June 15, 2023
Ref: #11505

Reference: Final Major Subdivision and Land Development Plan Application:
Jones Motor Tract – Residential Portion (Lot 1) & Recreation Land (Lot 3)
UPI Nos.: 21-5-10, 21-5-11, 21-5-12, 21-5-15.1, 21-5-15.4E and 21-5-15.4H
West Bridge Street (SR1039) and Schuylkill Road (SR0724)
Commercial-Oriented Mixed-Use Development (CMU) District
Final Plan Review
Township File #20-331

TYPICAL CROSS-SECTION OF LOCAL RESIDENTIAL STREET

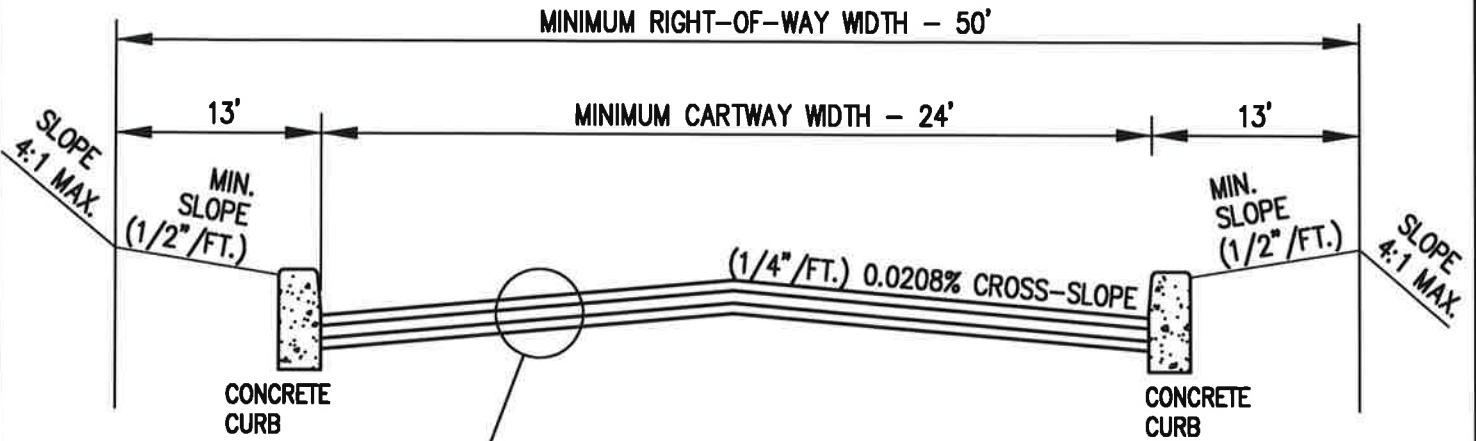
7. The road cross-section details on Sheet 67 should be revised to be consistent with the Township "Typical Cross-Section of Local Residential Street" Standard Detail dated July 6, 2022, attached.
